**Re: Windlectric Inc. - Application for Leave to Construct Transmission Facilities  
(EB-2014-0300)**

## **System Impact Assessment Report (2nd Addendum)**

**CAA ID: 2011-433**  
**Project: Amherst Island**  
**Applicant: Windlectric Inc.**

**Date: September 11, 2015**

**Figure 1: Amherst Island Single-Line Diagram**

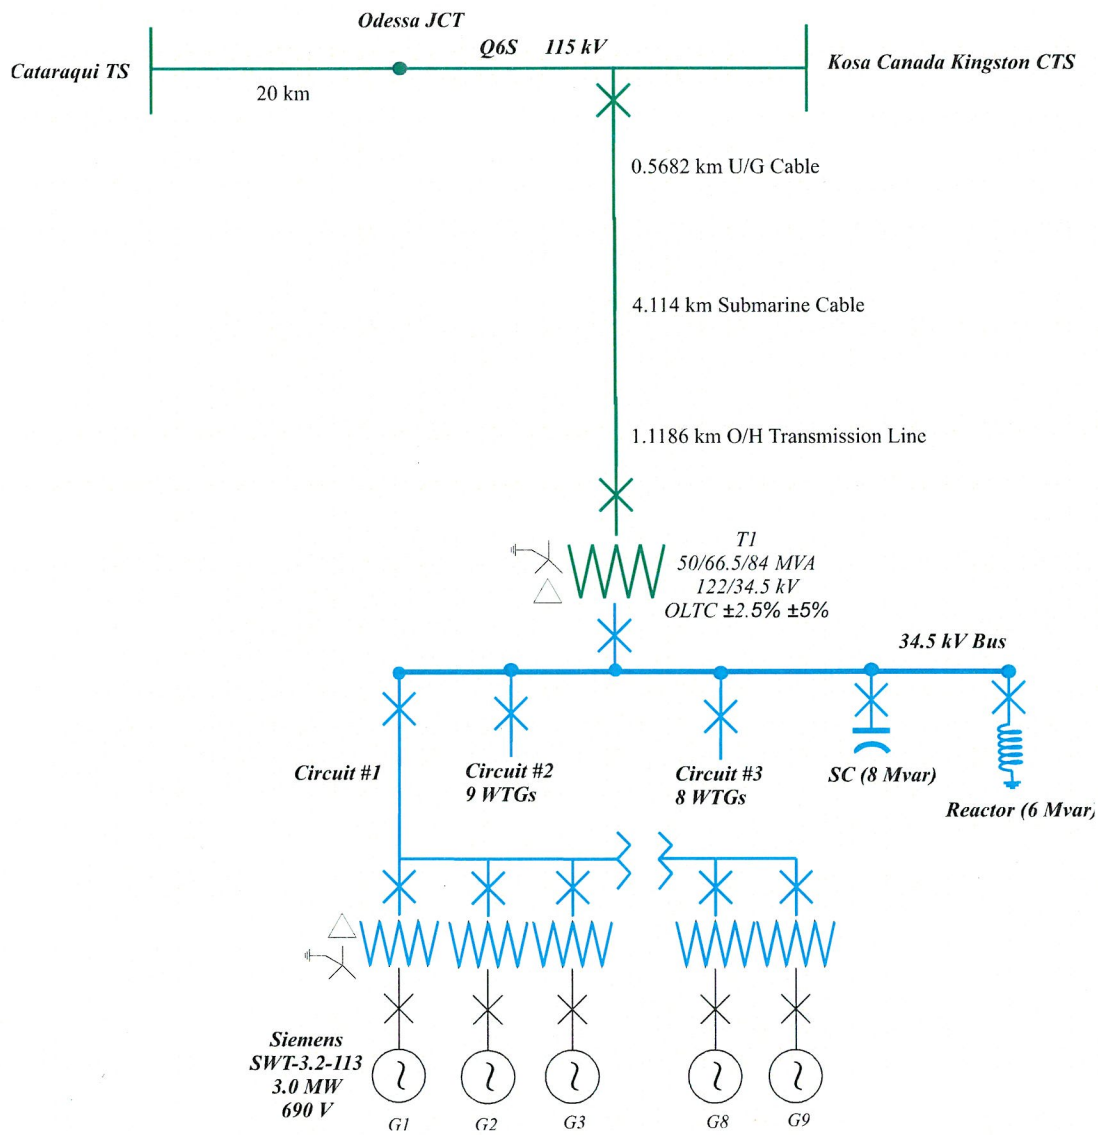
Based on the proposed change to the 115 kV tap line and the confirmation provided by the connection applicant that it is not possible to automatically disconnect the project's collector system when the WTGs automatically disconnect, static reactive power compensation of 8 Mvar capacitive and 6 Mvar inductive at 34.5 kV would need to be installed at the project's collector bus to satisfy the Market Rules requirements for reactive power.

This requirement of providing an 8 Mvar capacitive and 6 Mvar inductive reactive power compensation supersedes the connection applicant's specific requirement (1) in the first Addendum report, which recommends an 8 Mvar capacitive and 8 Mvar inductive reactive power compensation. All of the other requirements specified in the original SIA and the first addendum continue to apply.

The System Impact Assessment and an addendum for Amherst Island Wind Farm (CAA ID 2011-433) were completed on April 18, 2012 and May 12, 2015, respectively. Recently, the connection applicant has notified the IESO that the project's wind turbine generator (WTG) type has changed from Siemens SWT 2.3 VS to Siemens SWT-3.2-113. In addition, the number of WTGs will decrease from 33 to 26. Figure 1 shows the connection arrangement of the modified project. In addition, the connection applicant also provided updated parameters for the collector system.
